**PROJECT NUMBER: 689**

**SUBJECT:** Transmittal of the industry's partial responses to the NRC Staff's fifty-two Requests for Additional Information (RAIs) on the S2.1 task report, *Effect of Seismic Wave Incoherence on Foundation and Building Response*

## COMMENTS AND RESPONSES TO NRC REQUESTS FOR ADDITIONAL INFORMATION (RAIs)

The NRC submitted 53 RAIs related to the S2.1 Task on June 1, 2006. These RAIs were titled “Section 4.0 –Comments on EPRI Report 1012966 *Effect of Seismic Wave Incoherence on Foundation and Building Response (S2.1)*”. The industry responses and resolutions for these 53 RAIs are documented below.

Figure I-2. Comparison of the Abrahamson and the Luco and Wong coherency models at separation distances of 10 m and 45.75 m (= 150 ft).

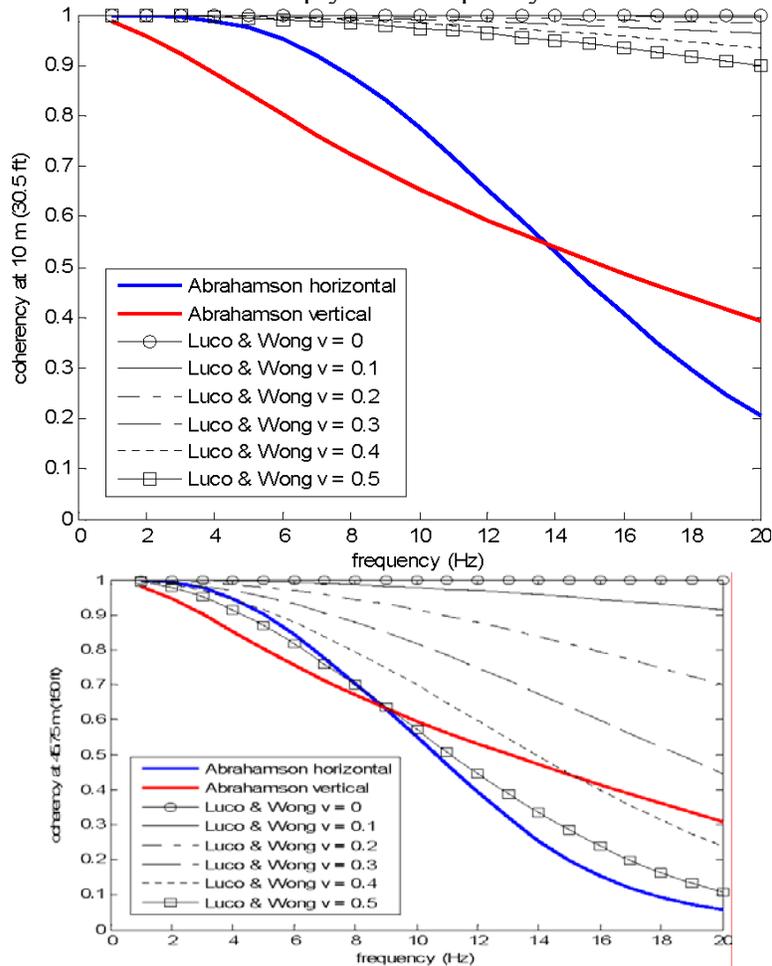
Figure I-3b indicates that rocking caused by the vertical motions (subfigure (c)), and torsion caused by the horizontal motions (subfigures (d) and (e)) can be significant, and increase as  $\nu$  increases (and coherency decreases, Fig. I-2). It is also noted from Fig. I-3b, subfigures (c), (d) and (e), that as  $\nu$  increases, the peaks of  $\sqrt{A_{33}^{44}}$ ,  $\sqrt{A_{33}^{55}}$ ,  $\sqrt{A_{11}^{66}}$  and  $\sqrt{A_{22}^{66}}$  shift towards the lower frequencies. On the other hand, the negligible effect of rocking discussed on p. 6-10 of the EPRI report appears to be counter-intuitive, in that the large reductions in the translational response due to incoherency presented in the report do not result in any rotational effects. Since the Abrahamson coherency model drops more rapidly with frequency and separation distance than the Luco and Wong model (Fig. I-2), this should lead to even higher values for the rotational transfer functions, but it is stated in the report that their effect is negligible. Does the rotational effect become negligible in the report’s study, because, due to the sharp decay of the Abrahamson coherency model, the peak of the rotational transfer functions shifts to such low frequencies where the ground motions do not contain much energy? How do all elements of the  $[S_{UoI}]$  matrix of Eq. 3-2 (not only the translational ITFs) behave at different frequencies?

4.52 The ITFs calculated in the present study are presented in Figures 4-13, 4-14, 4-15 and 4-16. These ITFs demonstrate the same shape and trends as Figure 2 of the study by Kim and Stewart (*Kinematic Soil-Structure Interaction from Strong Motion Recordings* by Seunghyun Kim and Jonathan Stewart, Journal of Geotechnical and Geoenvironmental Engineering, April 2003). This Figure 2 depicts the amplitude of the transfer function between free-field motion and the foundation input motion for different foundation shapes based on analytical formulations from Veletsos, Prasad, Luco, Wong, etc. as described in the above reference.
